Certified Recommendation
of the City of Raleigh Planning Commission

Case File 1 Name: **SP-17-07 408 South Bloodworth Street**
SP-I8-07 412 South Bloodworth Street

Staff Report

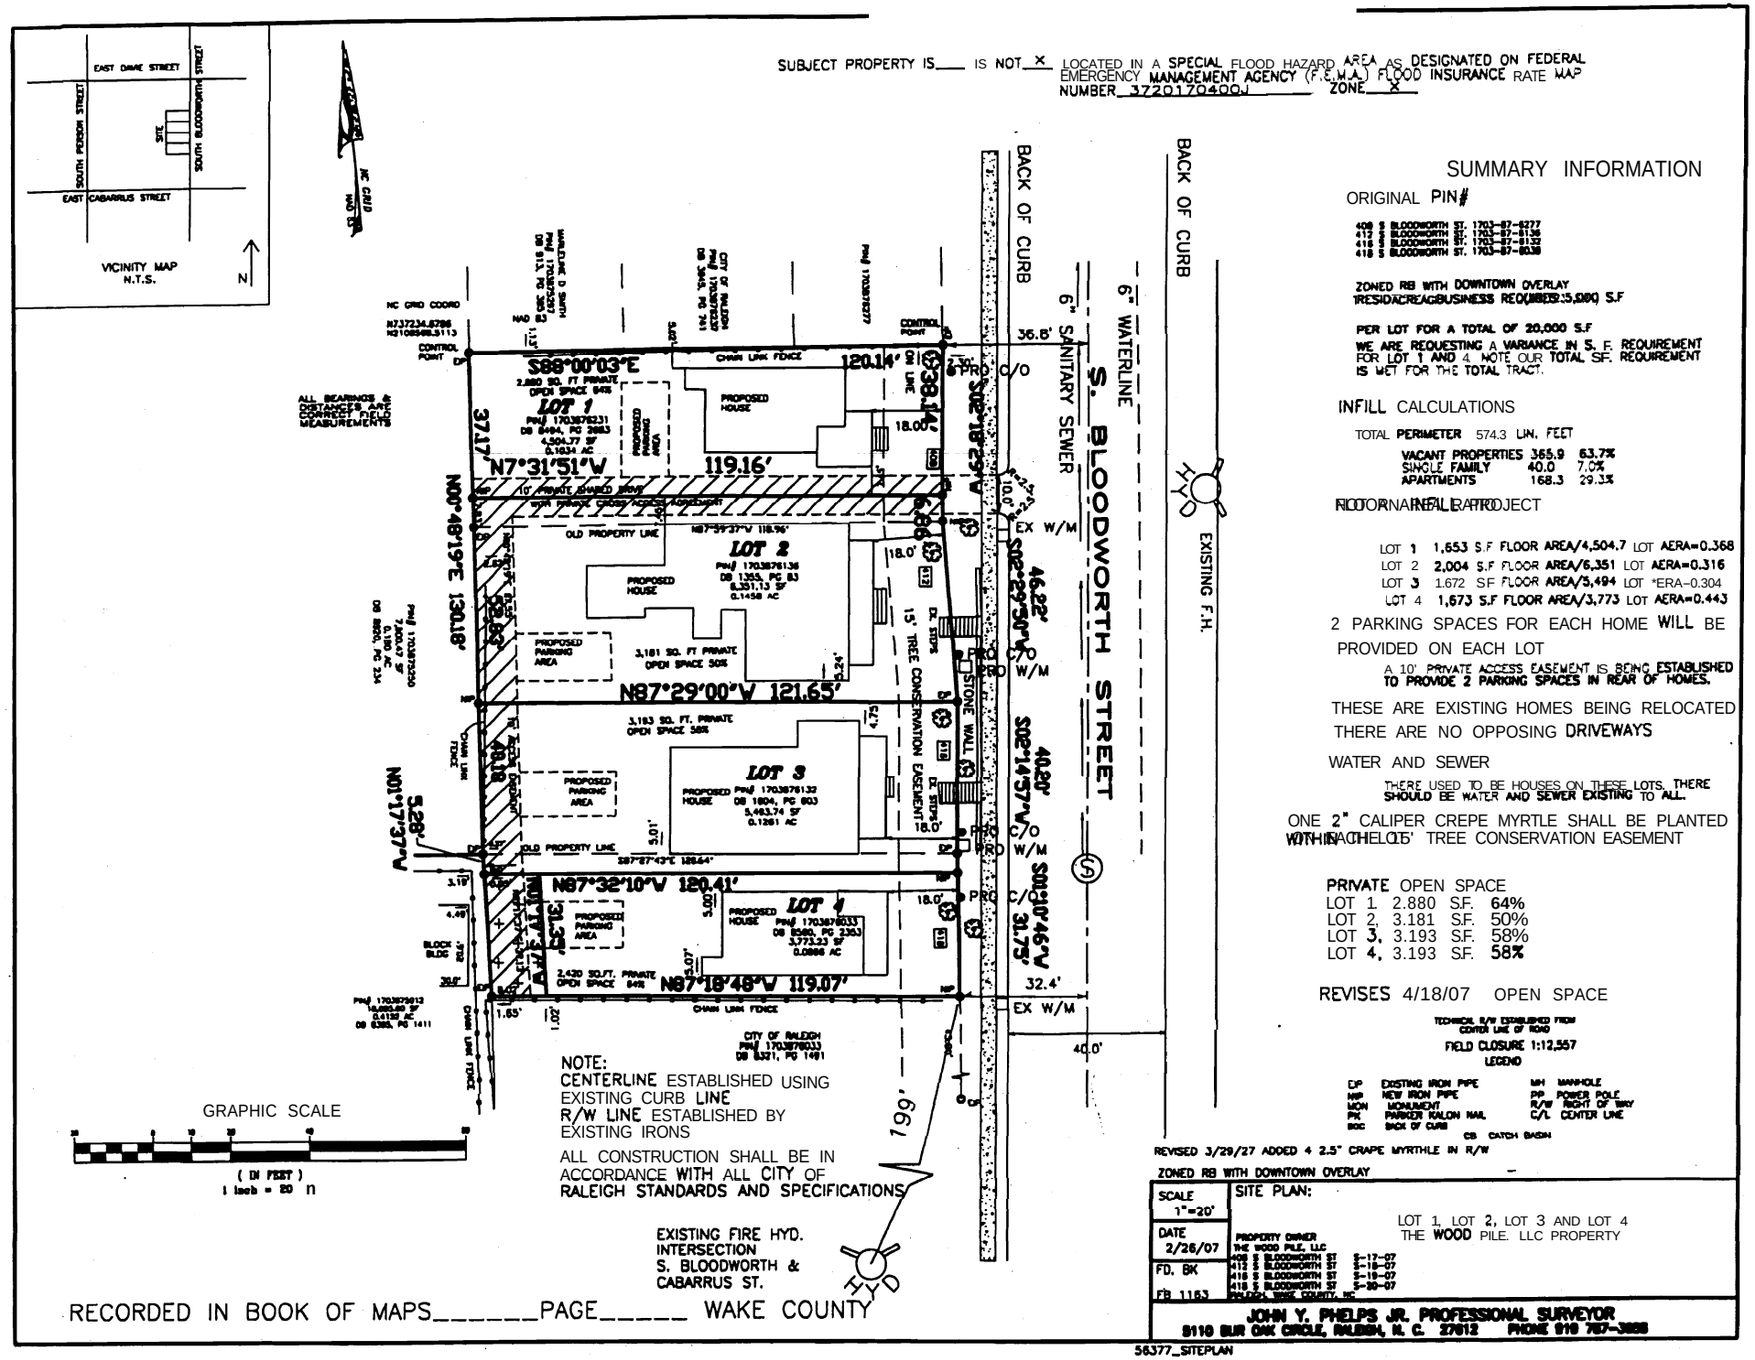
(4) That cross access agreements between lots 1, 2, 3 and 4 are recorded in accordance with the City Code and a recorded copy is returned to the Planning Department within 14-days of recording. If a recorded copy of this recorded document is not provided to the Planning Department within the 14 day period, further plat recordings and building permits authorization may be withheld;

(5) That a final detailed landscape plan meeting the street yard requirements of section 10-2082.5 of the Raleigh City Code be submitted and approved by the Site Review Specialist in the Inspections Department;

(6) That an application for an encroachment agreement for existing steps, landscaping and stone retaining wall located within the public right-of-way, as indicated on the preliminary plan, is submitted to the City's Encroachment Coordinator in the Inspections Department for review;

(7) That the encroachment agreement for the existing steps, landscaping and stone retaining wall located within the public right-of-way is approved by the City Council by separate action. Following City Council approval of the encroachment, an encroachment agreement prepared in accordance with Raleigh City Code Sections 12-1001 and 12-1021(a), shall be filed with the Inspections Department, and the encroachment agreement is to be recorded with the Wake County Register of Deed Office. Maintenance of the encroachment shall be the responsibility of the owner.
